Extract from Pre-application advice note - PRE/2022/009 from Haringey

Revisions: A 07.12.2022 Minor amendments B 07.12.2022 Text altered		For planning	
		FER 215	Proposed block plan and sections
		Scale 1:250 @ A3	Garage site on Ferrestone Road N8 7BX
		Sept 2022	
		Appleton Weiner	
		19 Wallace Road London N1 2PG Telephone 020 7253 8387 ALL DIMENSIONS TO BE CHECKED ON SITE. DISCREPANCIES TO BE REFERRED TO APPLETON WEINER. DO NOT SCALE OFF THIS DRAWING. ALL DRAWINGS RETAIN APPLETON WEINER COPYRIGHT ©

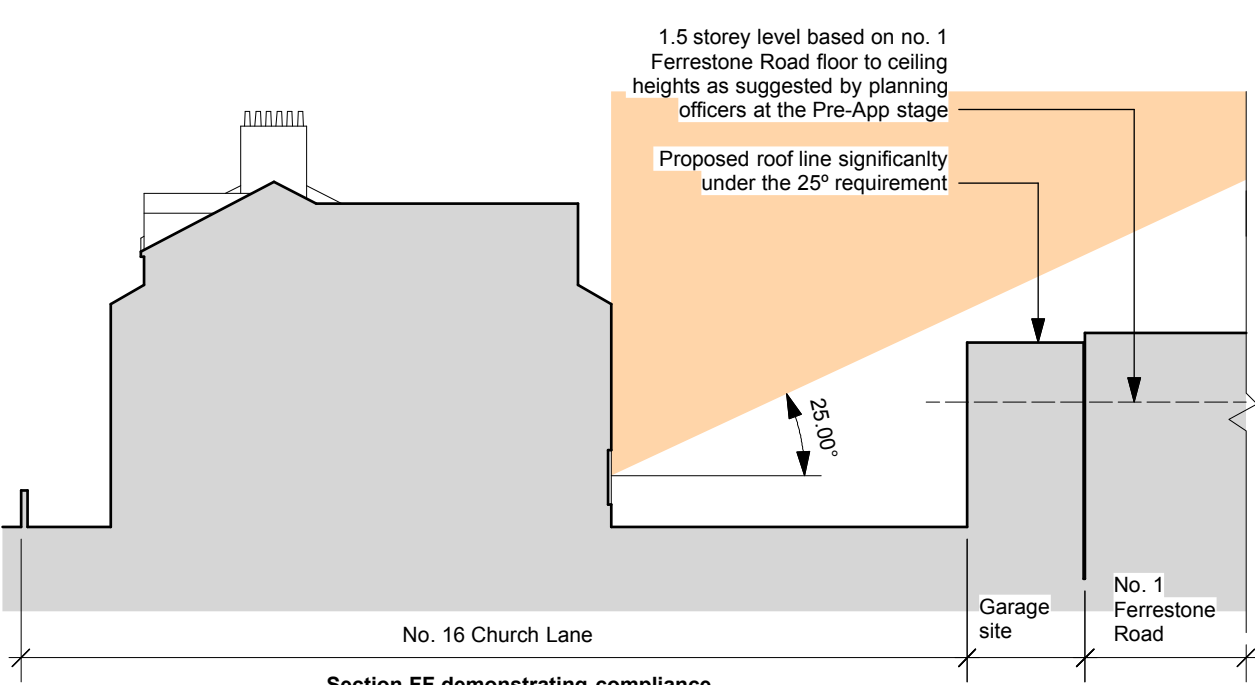
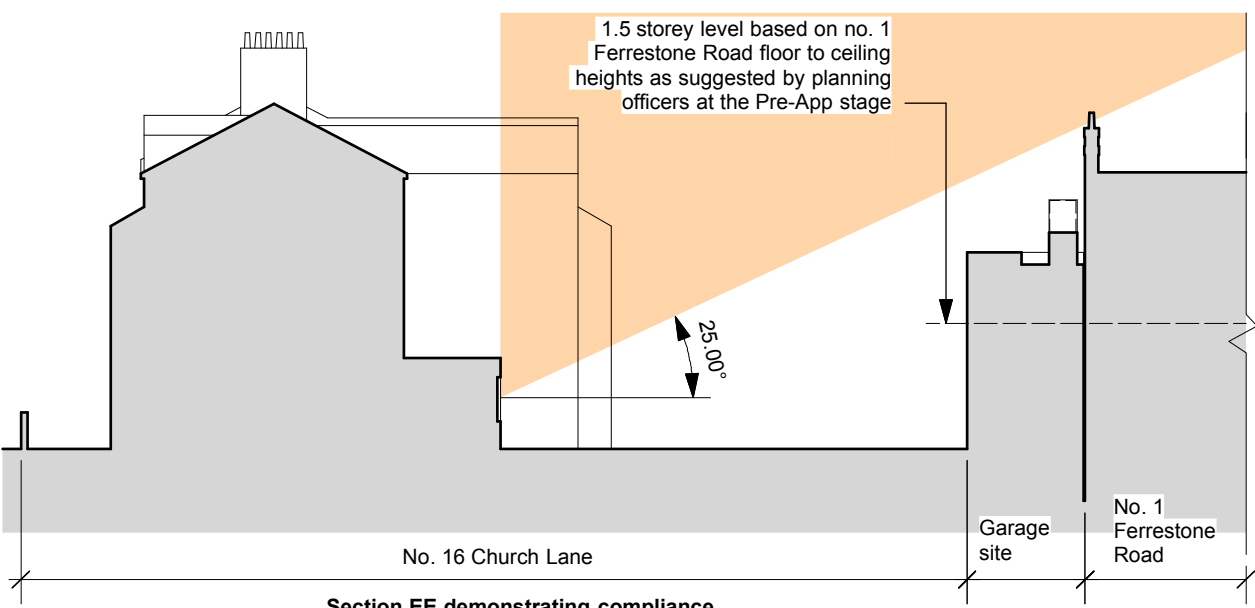
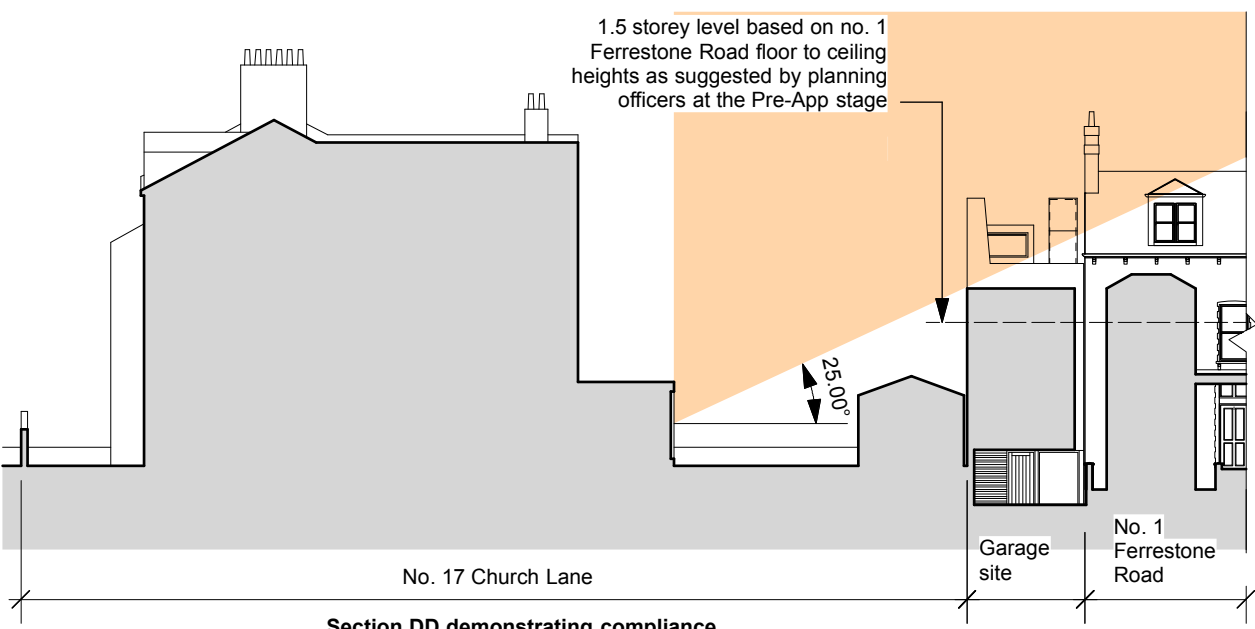
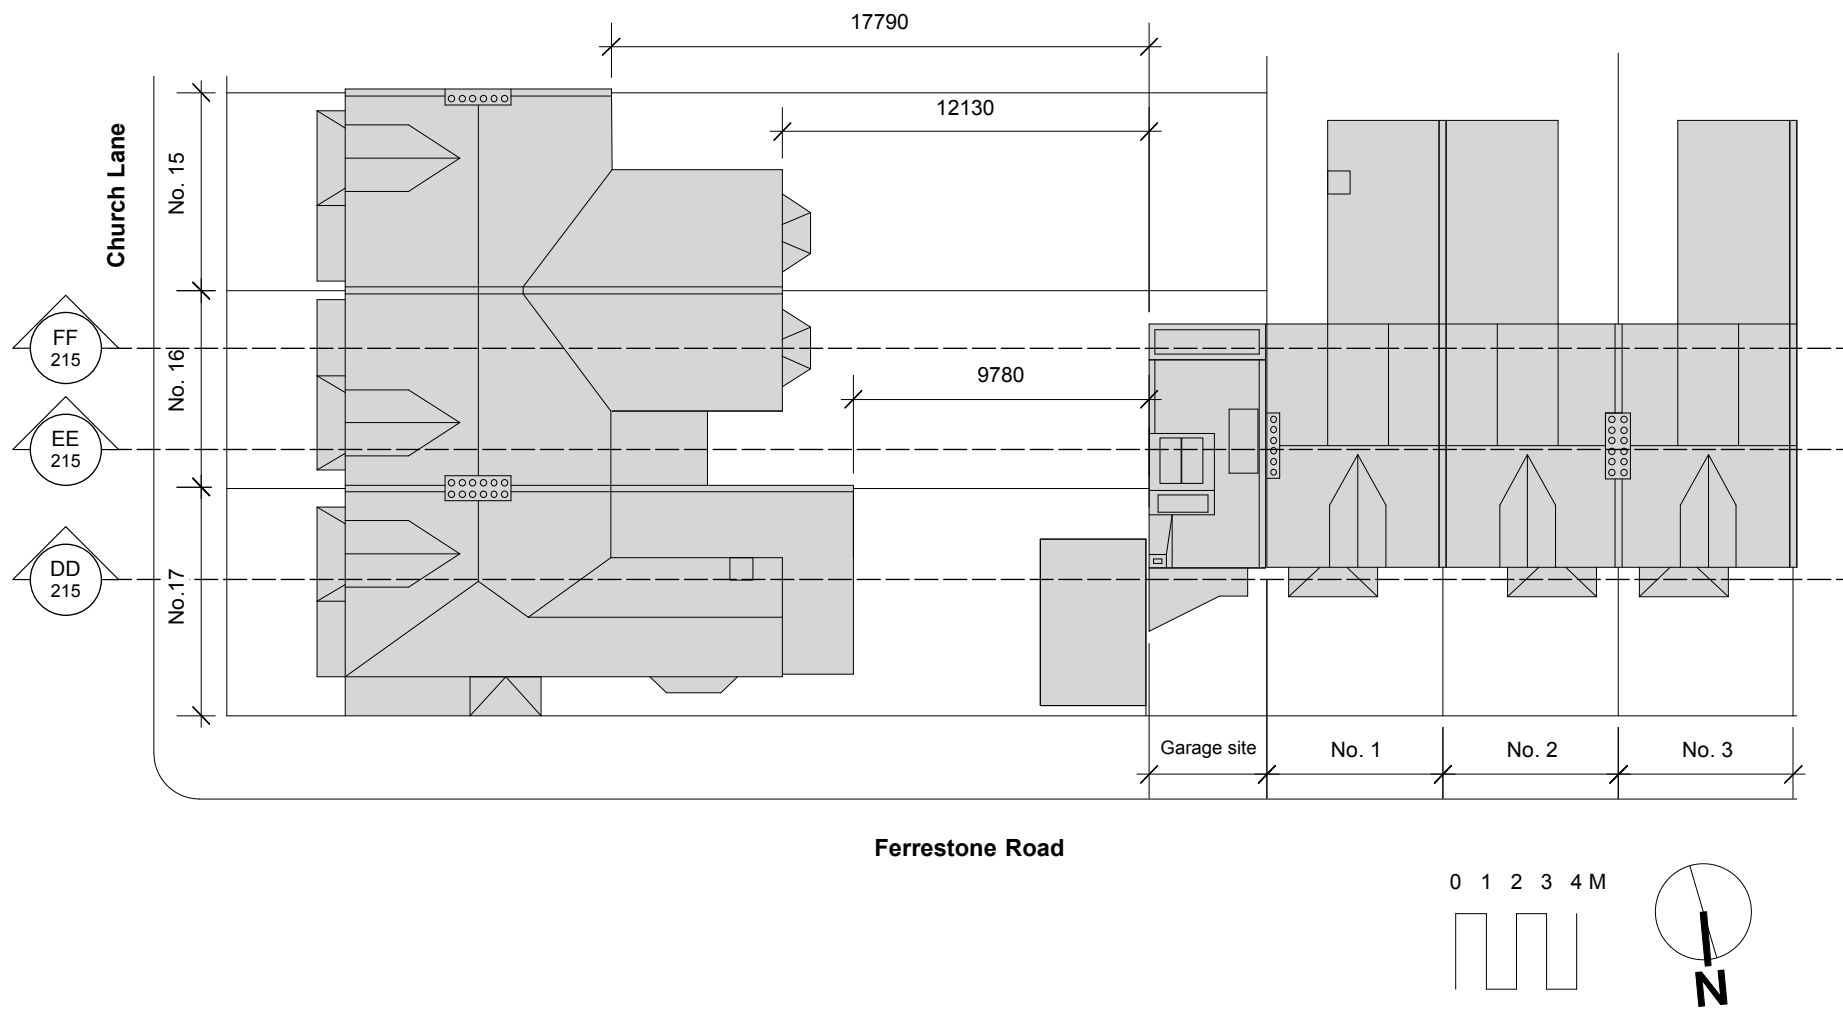
"A building (of single-storey up to 1.5 storeys (above ground level) is likely to be acceptable, subject to the roofline not being higher than a 25-degree line from the rear windows of 16 and 17 Church Lane (on section drawings)."

Architect's response:
The proposed section drawings clearly demonstrate compliance with this requirement and we, therefore, cordially request the taller building proposal be duly supported on its merits by planning officers.
